Revision 7 March 2020

Dealer Service Instructions for:

# Customer Satisfaction Notification V41

## Steering Damper

Figure 1 – Steering Damper

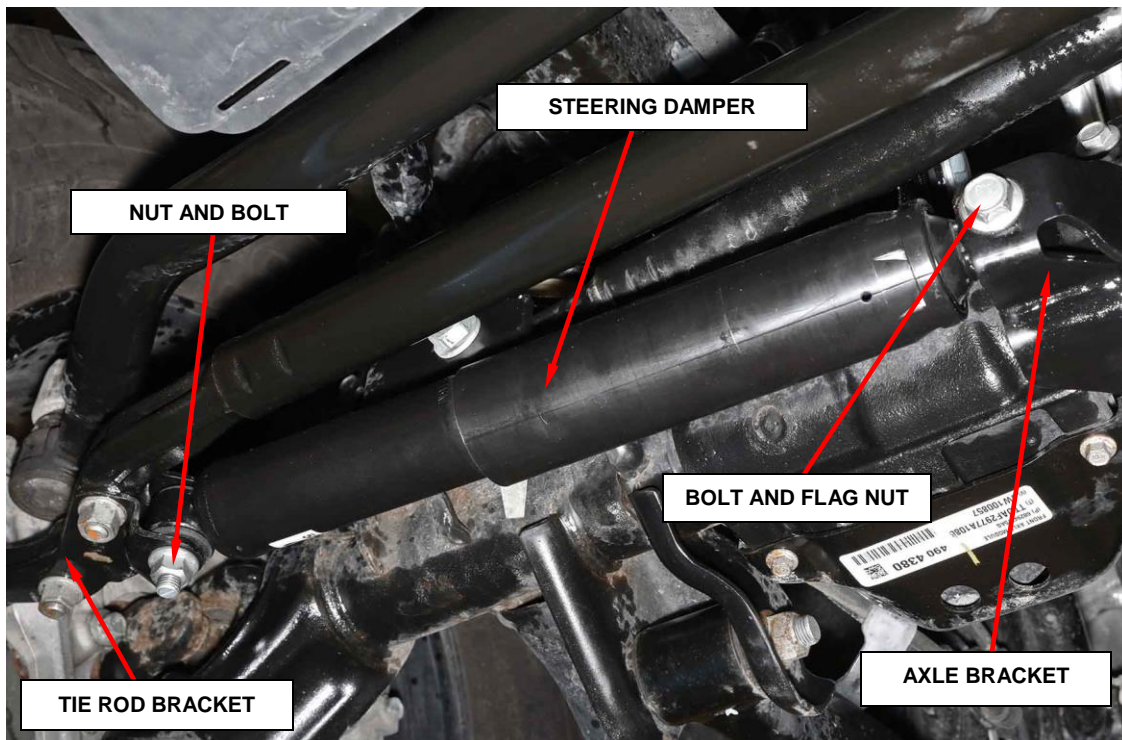
1. Place the front wheels in a straight ahead position.
2. Raise and support the vehicle.
3. Remove the steering damper nut and bolt from the tie rod bracket (Figure 1).

- Install the **NEW** steering damper bolt through the axle bracket and start it a few threads into the **NEW** flag nut (Figure 1).
- Install the **NEW** steering damper bolt through the tie rod bracket and start it a few threads into the **NEW** nut (Figure 1).

12. Tighten the **NEW** steering damper bolt on the axle bracket to 80 N·m (59 ft. lbs.) (Figure 1).
13. Tighten the **NEW** steering damper nut on the tie rod bracket to 80 N·m (59 ft. lbs.) (Figure 1).
14. After the steering damper is installed in the correct orientation (base cup bulge at 6 o'clock location) lower the vehicle on the ground (Figure 5).
15. Return the vehicle to the customer.

**Figure 2 – Steering Damper****Figure 3 – Damper Orientation**

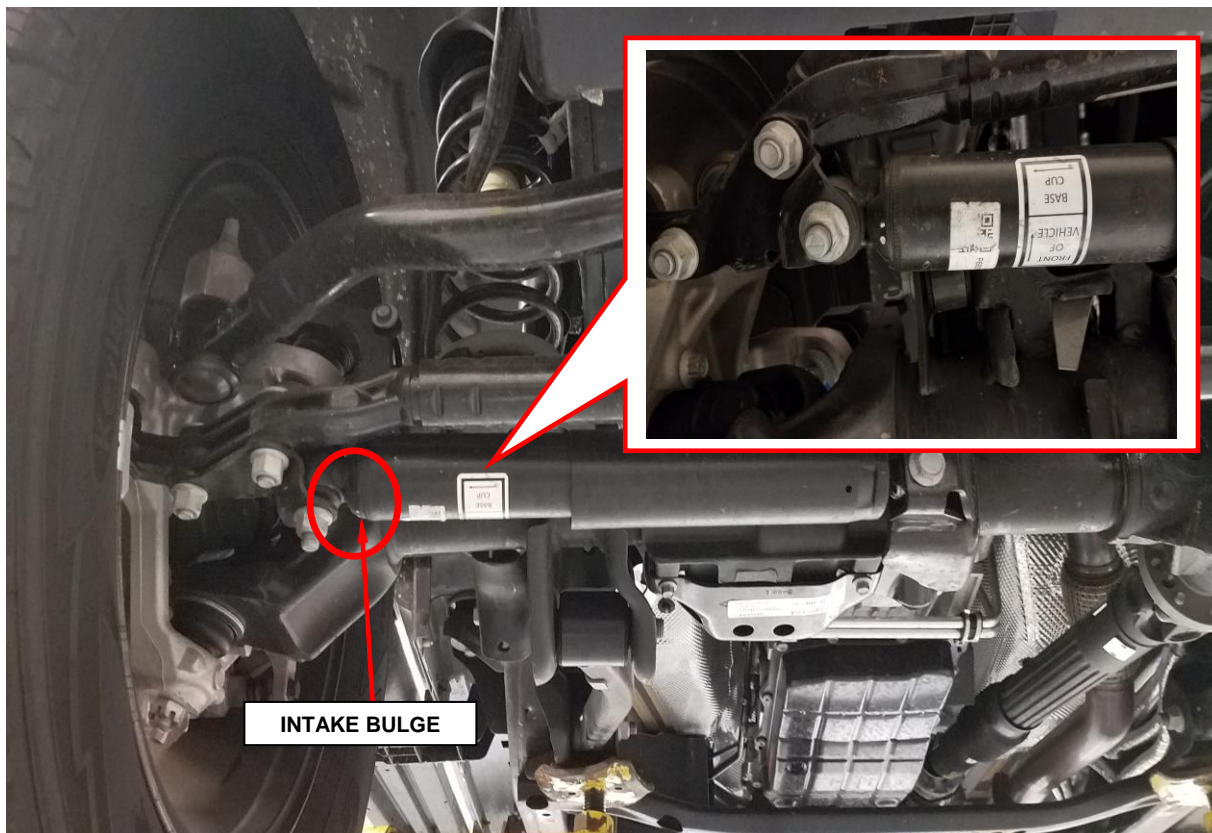
6. Before installing the NEW steering damper, hold the steering damper rod in a vertically up position as show in the illustration below (Side Intake Base Cup in a downward Position) (Figure 2).

7. With Damper Rod orientation in the up position, insert a long bolt or a suitable tool through both mounting bushings (Figure 3).

**Figure 5 – Intake Bulge Location**

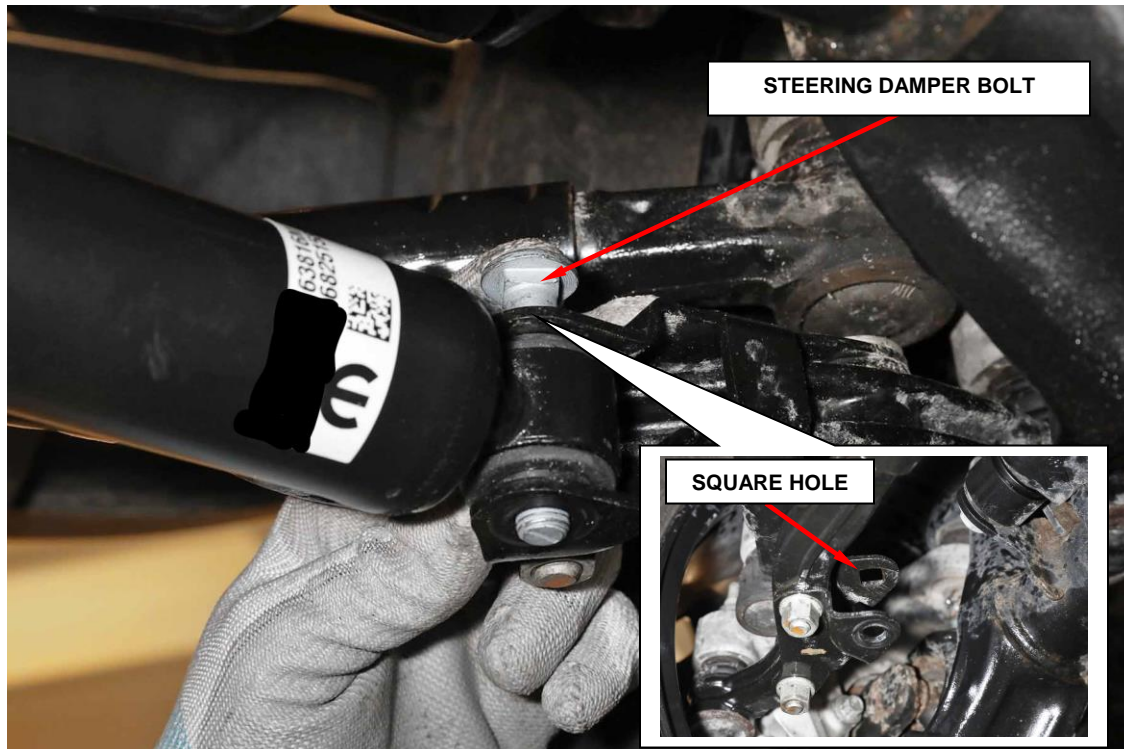
**NOTE:** Location of side Intake Bulge on the base cup must be positioned in the downward position and the arrow on the damper label must point to the front of the vehicle (Figure 5).
